SERVICE BULLETIN # 00002

SUBJECT: Anti-Tip Shim

MODELS: Electro-Mechanical, Merlin 2000, Merlin III

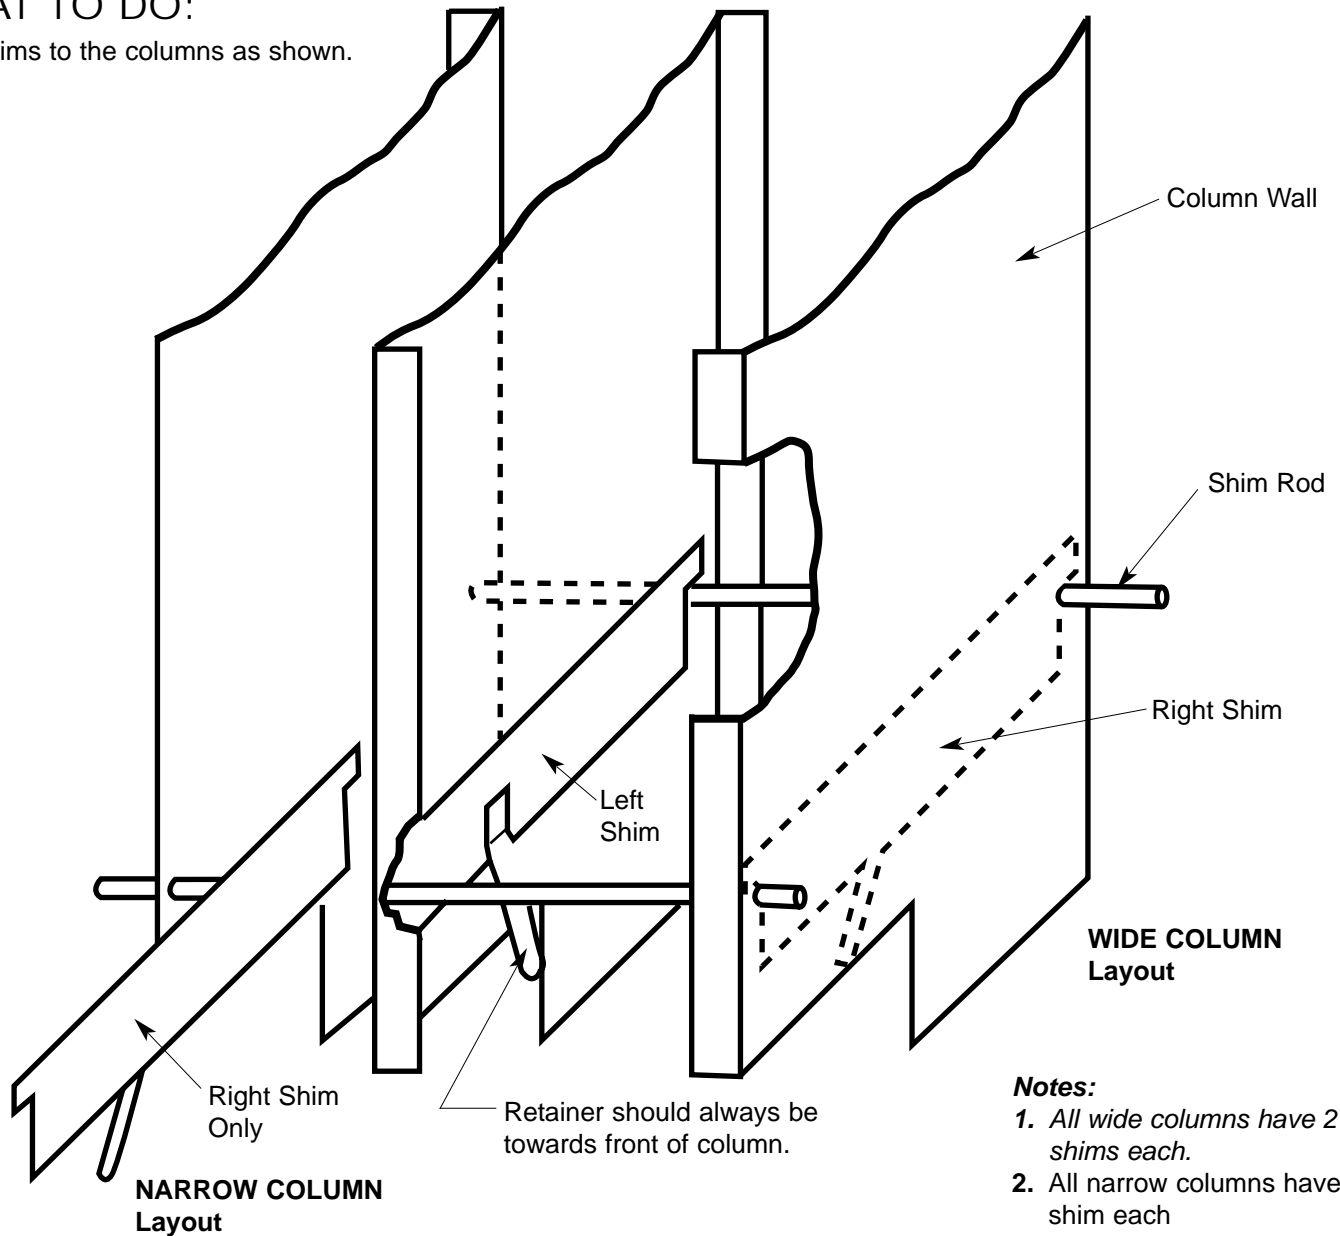
To keep the rear can from being moved forward by rocking the vender to obtain a free can.

Add Shims to the columns as shown.

- Notes:**
1. All wide columns have 2 shims each.
 2. All narrow columns have 1 shim each
